# UNITED STATES PATENT AND TRADEMARK OFFICE

APPLICATION NO.	FILING DATE	FIRST NAMED INVENTOR	ATTORNEY DOCKET NO.	CONFIRMATION NO.
10/734,424	12/12/2003	Bernhard Sander	DT-6716	3920

## DETAILED ACTION

Aoki et al., 6,679,282

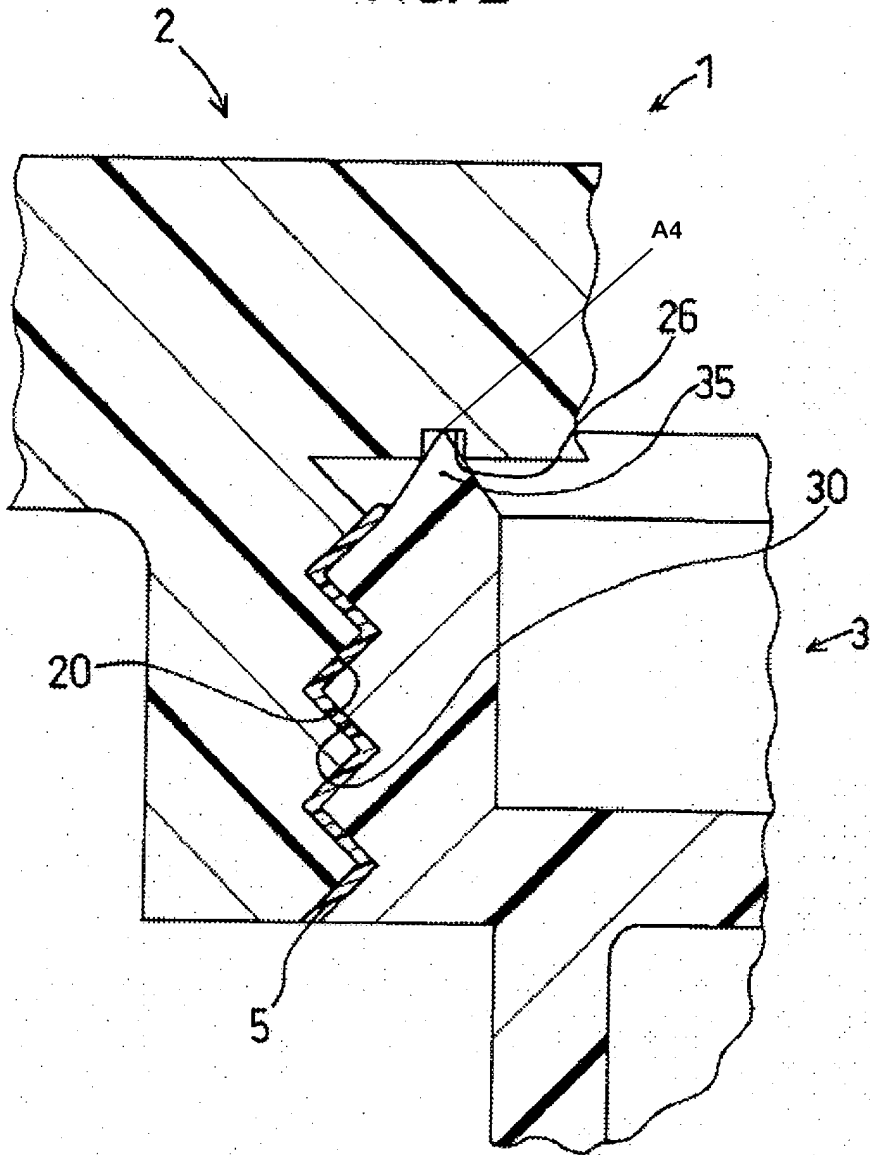
Regarding claim 1, Aoki et al. disclose, in Figure 2, a coupling between a tool receptacle **1** and a tool **2** with two oppositely directed contact means **26,35** facing one another. At least one of the contact means **26,35** has a pointform **A4**.

Regarding claim 7, Aoki et al. disclose the coupling in combination with a pre-stressing means **5,20,30**,. The pre-stressing means **5,20,30**, comprises an axially directed screw-thread biasing member **5**.

Regarding claim 8, the screw-thread biasing member extends axially from the tool receptacle **1** into a threaded bore **20** extending axially into the tool **2**.

**Fig. 2**

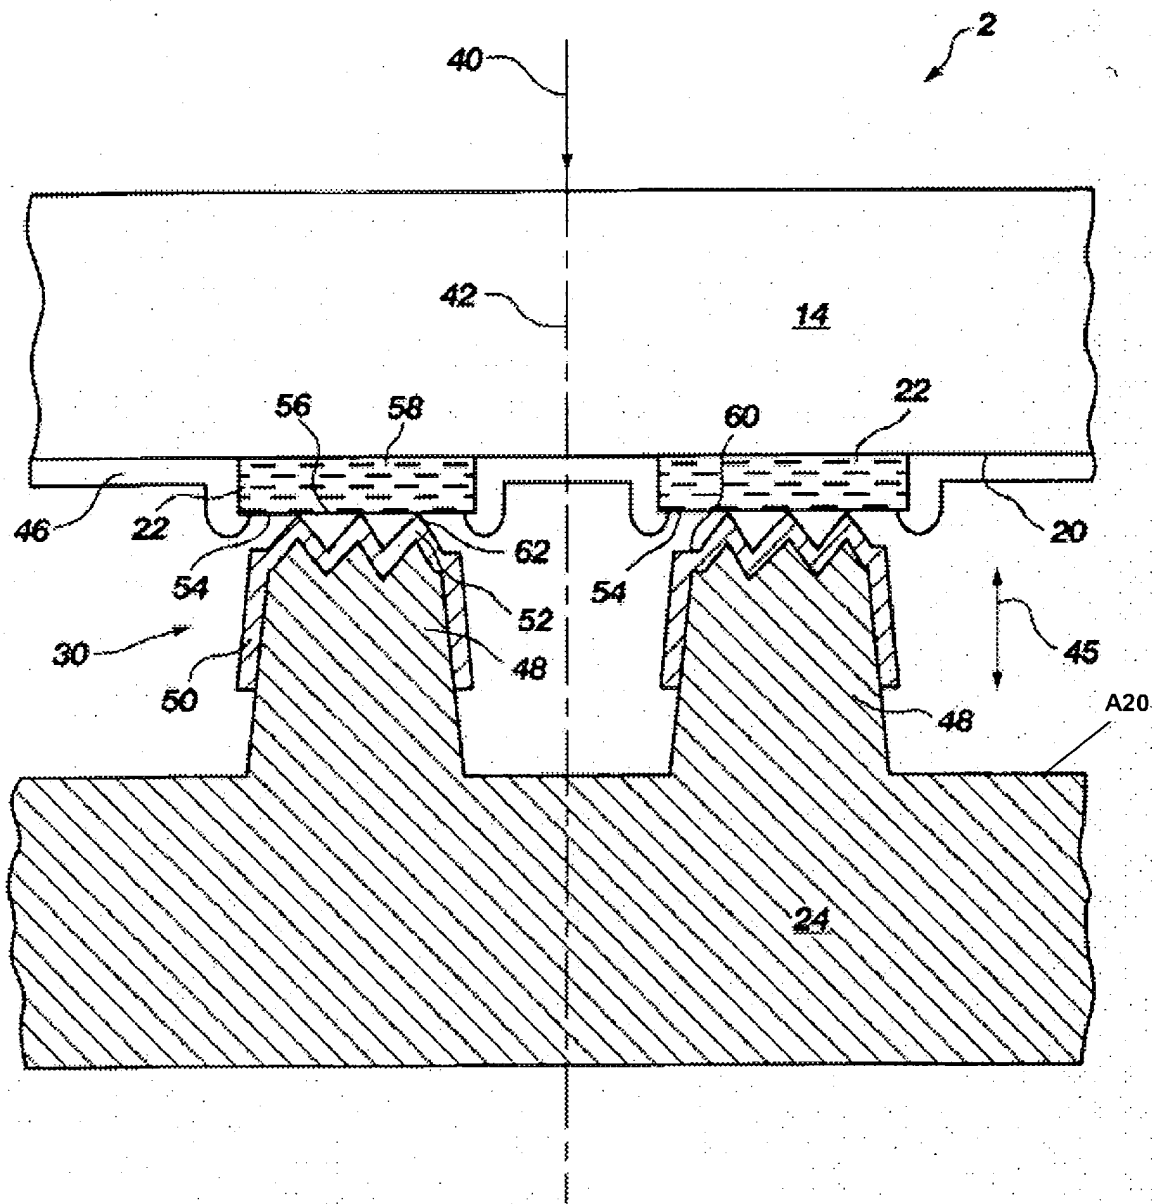
Regarding claim 1, Hembree et al. disclose, in Figure 2, a coupling between a tool receptacle **24** and a tool **14** with two oppositely directed contact means **20,A20** facing one another. At least one of the contact means **A20** has a pointform **48**.

Regarding claim 2, contact tips **52** are spaced apart forming the --at least one-- contact means **20,A20**.
